ASSESSMENT REPORT

Mangoola Coal Mine Section 75W Modification

Figure 2: Location of Approved and Proposed MIA Facilities, including the CHPP

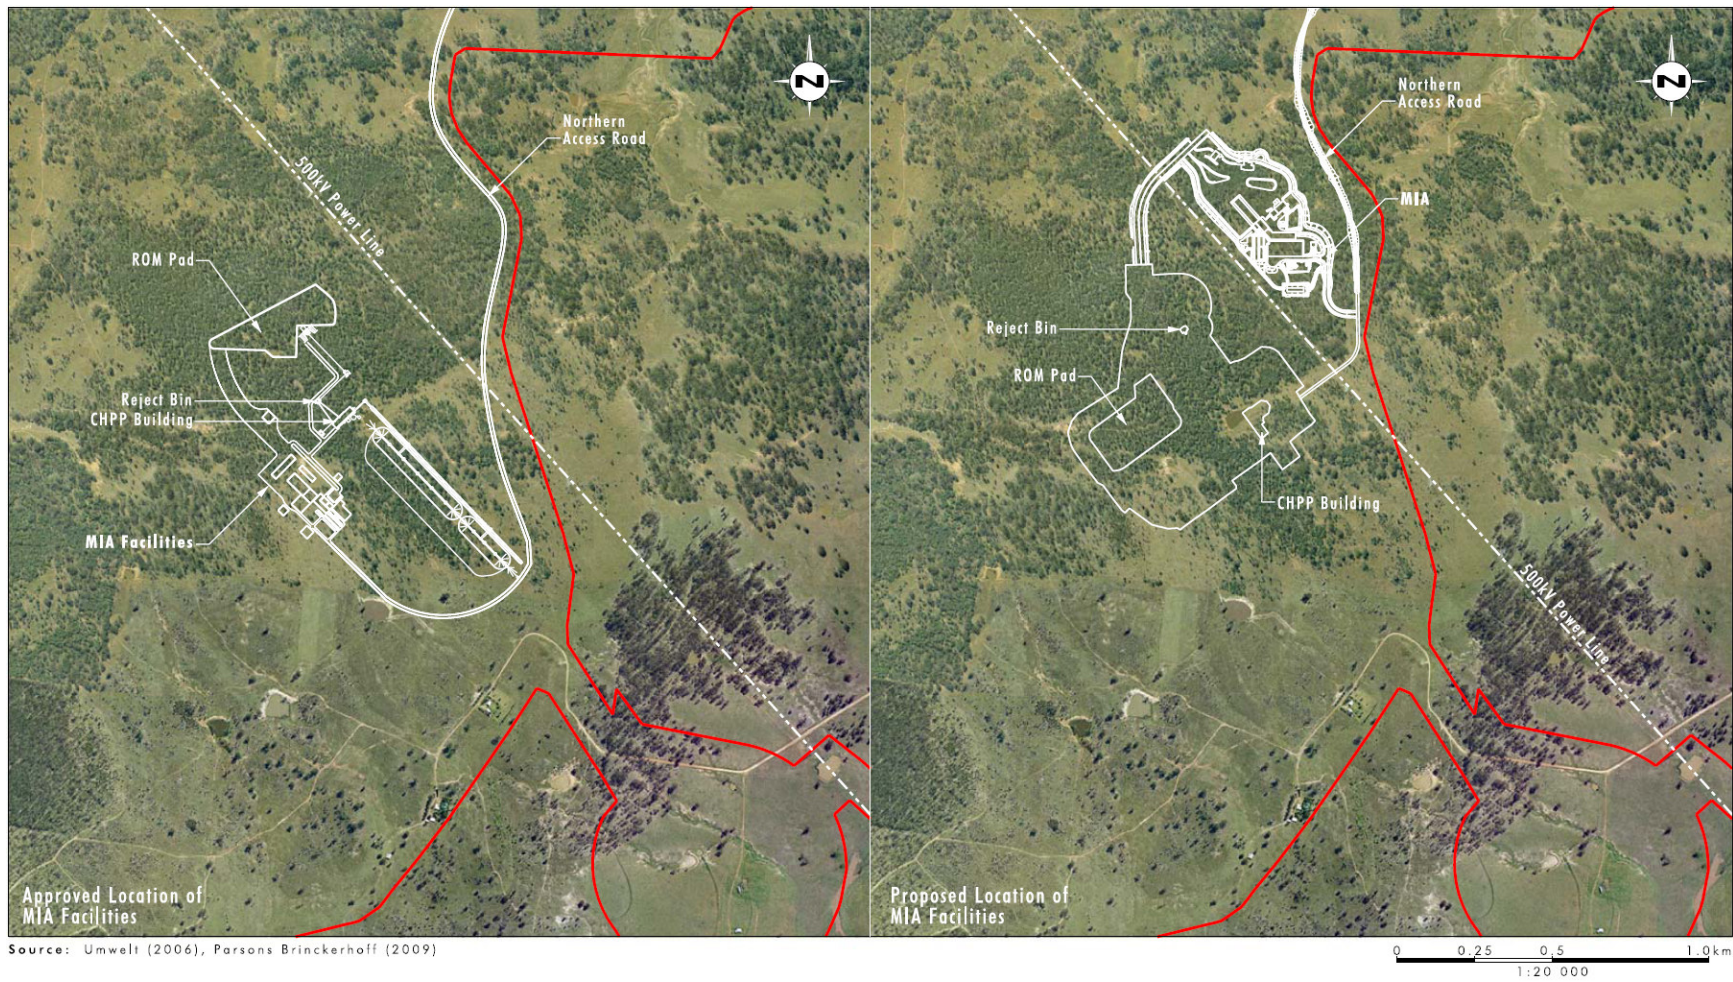
Xstrata proposes to relocate the Mining Infrastructure Area (MIA) approximately 1km north-north-east (NNE) of the approved location, see Figure 2. The relocated MIA would be contained within the approved project disturbance boundary; however the base level of the MIA facilities would be approximately 10 metres higher than the approved levels.

Minor design changes to the CHPP are proposed in order to improve site safety. These would be contained within the previously approved location of the CHPP and include:

- change the orientation of the CHPP building from NE-SW to NW-SE;
- change the position of the ROM stockpile pad, moving it 100 metres to the south; and
- change in base levels resulting in an increase in the height of the reject bin by 3 metres.

Figure 3: Visual Assessment Locations & Vegetation Screen

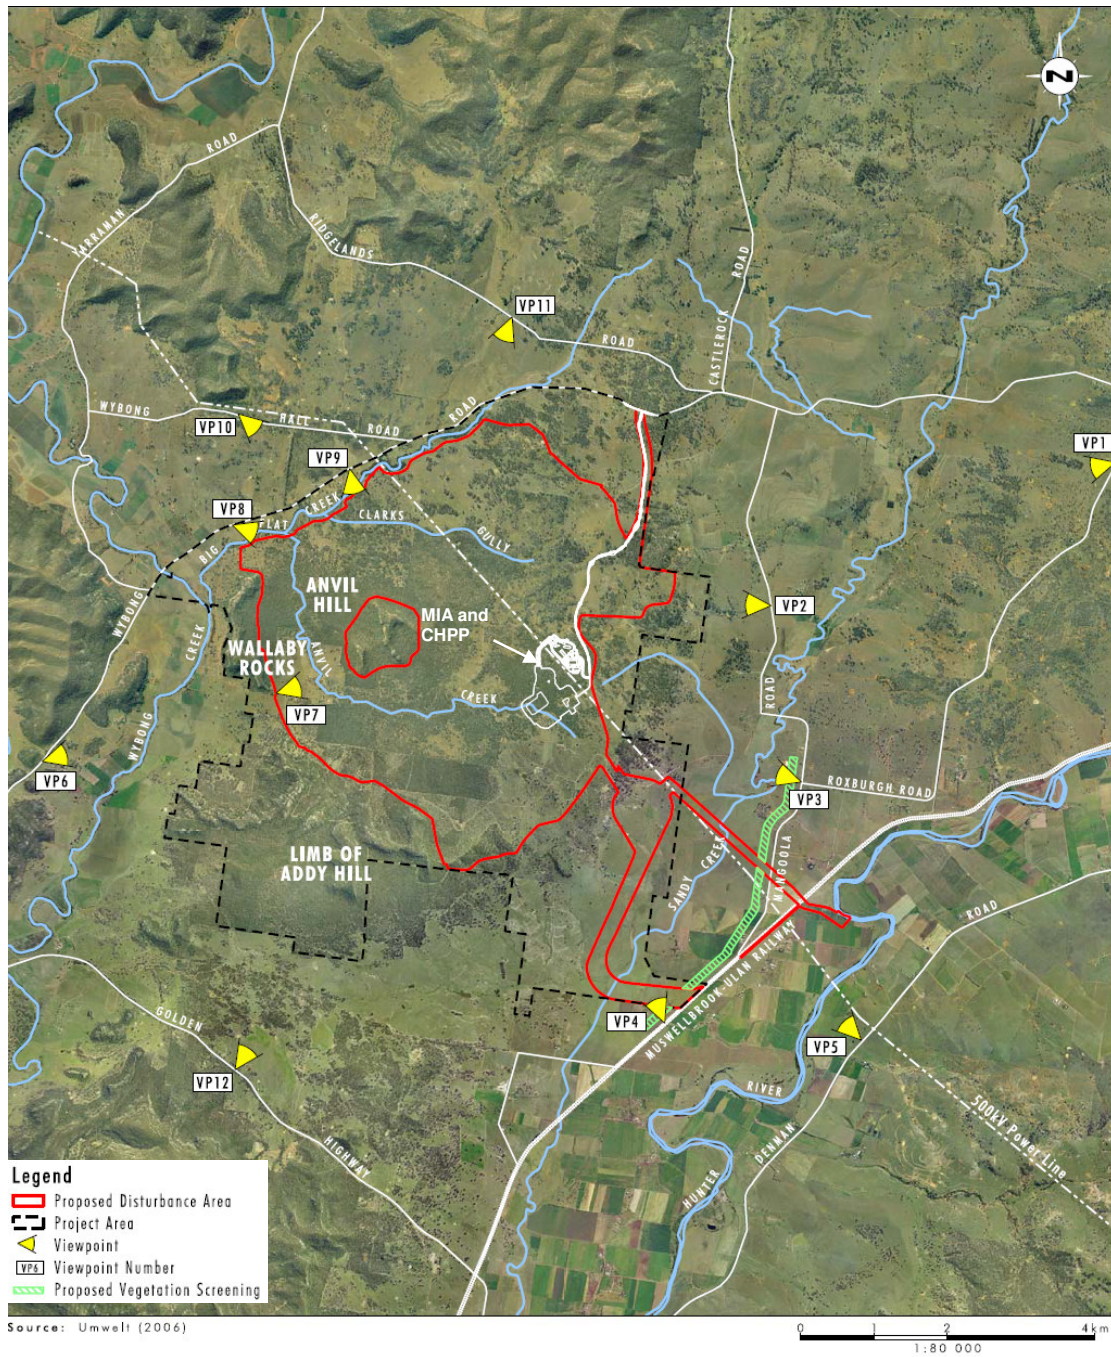
The visual assessment considered views from the same points as those assessed in the original Environmental Assessment (EA) and determined view points (VP) 1, 2, 3 and 4 to be the most affected, see Figure 3. These view points are located to the north-east, east and south of the proposed MIA and CHPP facilities and represent views from Mangoola and Roxburgh Roads.

The visual assessment concluded that the proposed location of the MIA, 1km NNE of the approved location remains within a moderate-high scenic quality zone as defined in the original EA. The assessment determined that there would be no change to the visual impact rating of VP1, 2 and 4. The rating at VP3 would change from moderate to moderate-high impact due to the MIA moving to the eastern edge of the ridgeline. VP3 represents the views experienced by traffic passing through the intersection of Mangoola and Roxburgh Roads. No private residences are located at this view point, with the nearest being over 1km to the east.

The assessment also considered the extent of screening vegetation between the MIA and the key view points. The assessment concluded that insufficient vegetation would remain on the eastern and southern slopes below the MIA to screen it from viewers at VP2, 3 and 4. Therefore, Xstrata has commenced planting a rapid growing vegetation screen along the western edge of Mangoola Road from the northern side of VP3 through to VP4 (see Figure 3). Vegetation has been planted between VP3 and VP4, with the section to the north of VP3 yet to be planted. This northern section is subject to a Ground Disturbance Permit procedure requiring Aboriginal stakeholder consultation prior to undertaking planting. Once mature, the vegetation would provide a reasonable level of screening of the MIA when viewed from Mangoola Road between VP3 and VP4.

The Department considers that the revised visual impacts at VP3, increasing from moderate to moderate-high, would have only a minor impact, given that there are no private residences in this location and the views to be affected are from passing traffic. The proposed vegetation screen from VP3 to 4 would, in time, minimise these impacts. The Department has recommended a condition requiring Xstrata to complete this planting early, to provide the maximum time for the vegetation to mature. As the section north of VP3 is subject to stakeholder consultation, and to avoid planting during the hottest months, the Department requires Xstrata to complete the planting no later than July 2010.

Figure 4: Residence Locations used for Noise Assessment

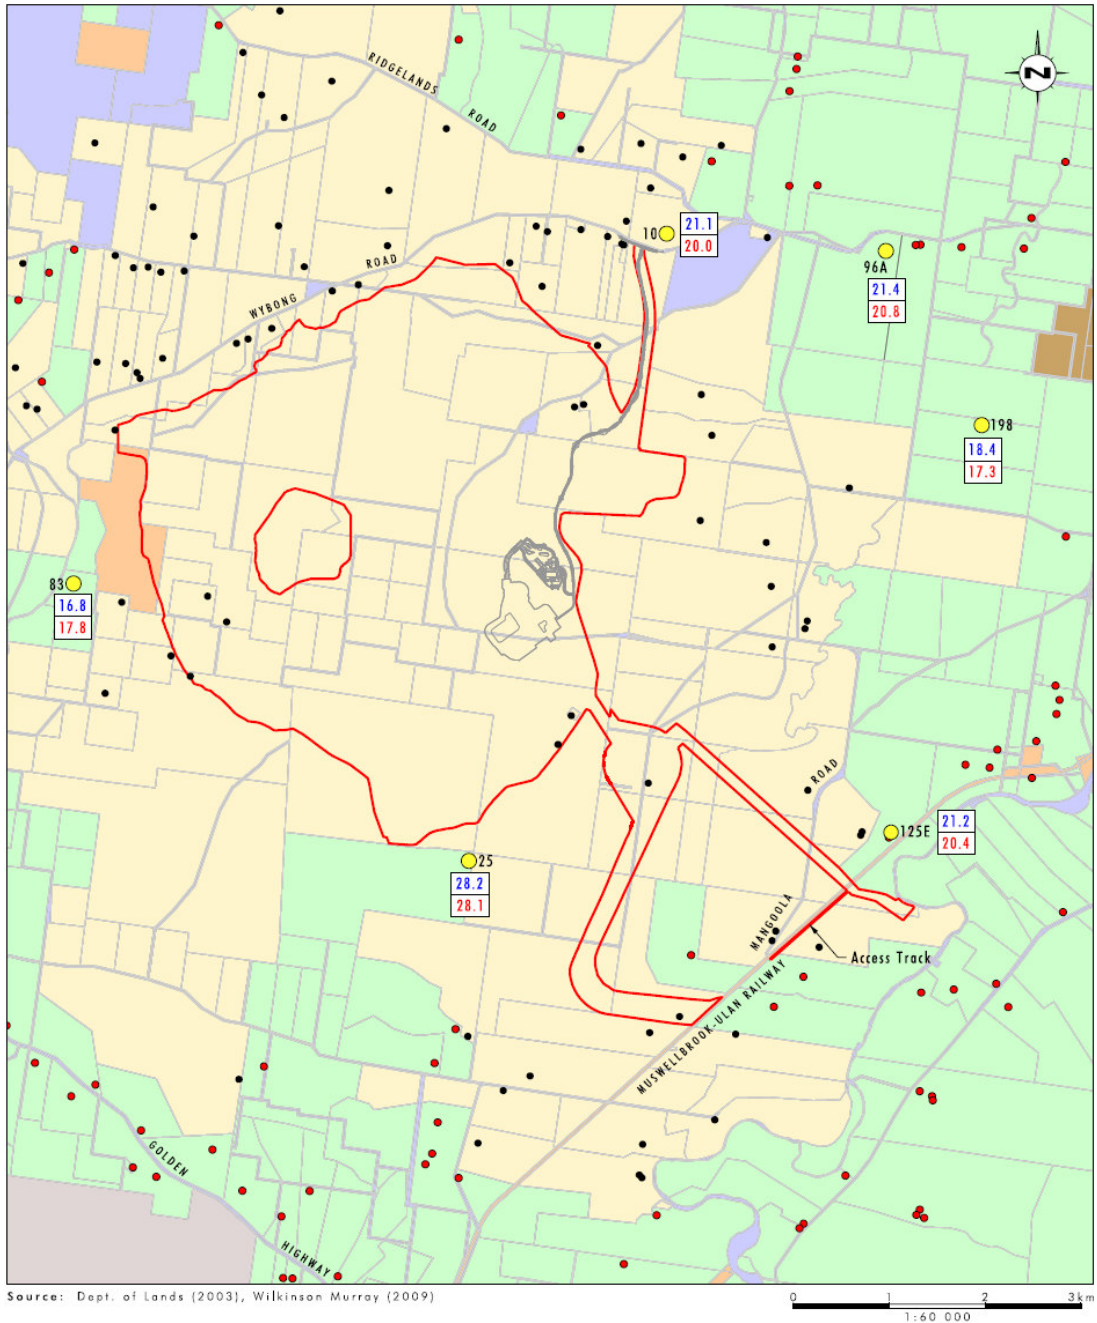
A noise assessment of the proposed modification was undertaken by Wilkinson Murray Pty Ltd. The assessment predicted noise level changes at six residences most likely to be impacted by the relocation of the MIA. These residences are shown on Figure 4. The results of the assessment are shown in Table 1 and summarised below.

The MIA is proposed to be relocated 1km to the NNE of the approved location. Residence number 83, located approximately 4.8km to the west is identified as the nearest residence to be impacted by increased noise due to the modification, albeit only a minor increase of 1dB(A). All other nearest residences to the north, north-east, south-east and south are predicted to experience a minor reduction in noise as a result of the modification.

The cumulative impact of noise from the MIA, CHPP and mining operations at residence 83 were considered in the original EA, with a worst case scenario of 35dB(A) predicted. The proposed increase of 1dB(A) from the MIA would not increase cumulative noise at this location such that the land acquisition criteria of 40dB(A) would be exceeded. However, it should be noted that this property already has land acquisition rights due to the impacts of air quality and blasting from the approved project.

The Department is satisfied with the level of additional noise assessment undertaken for the modification and considers that the predicted impacts would be negligible. No amendment to the conditions for managing noise impacts is considered warranted.
